Roadster 2012-13 en Can-Am Roadster - Fuel Cap Replacement

Bulletin type: **Safety Campaign**

Bulletin no: **2012-13** (rbg2012-013 en AP)

Subject: **Can-Am™ Roadster - Fuel Cap Replacement**

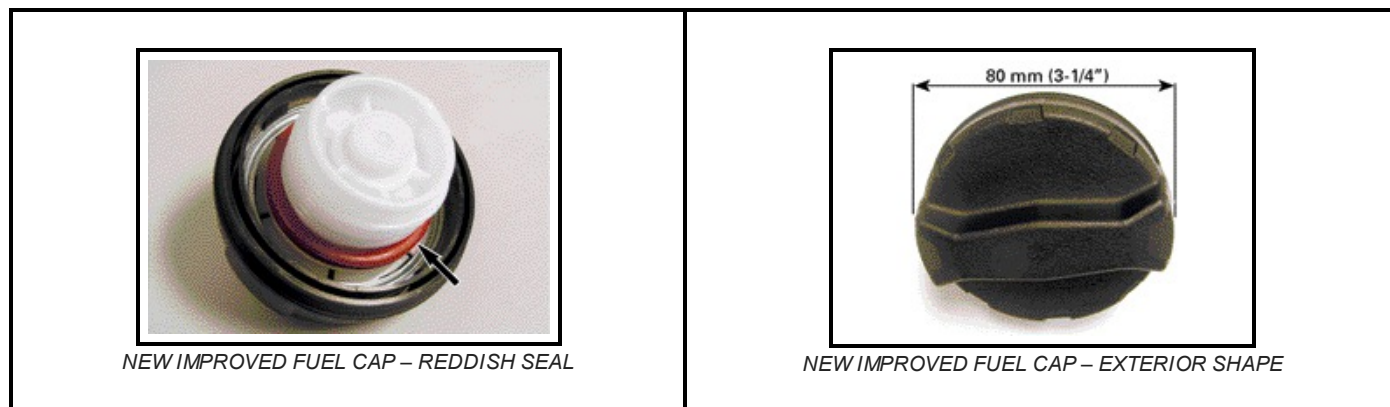
The fuel cap may not seal properly the fuel tank filler neck. Fuel vapors in the presence of an ignition source could result in a fire.

NOTE: For reference, please see below pictures that will help you identify the new fuel cap which has a reddish color seal AND a different size handle.

Install new improved fuel cap.
 Discard the old one.

Install the new improved fuel cap.
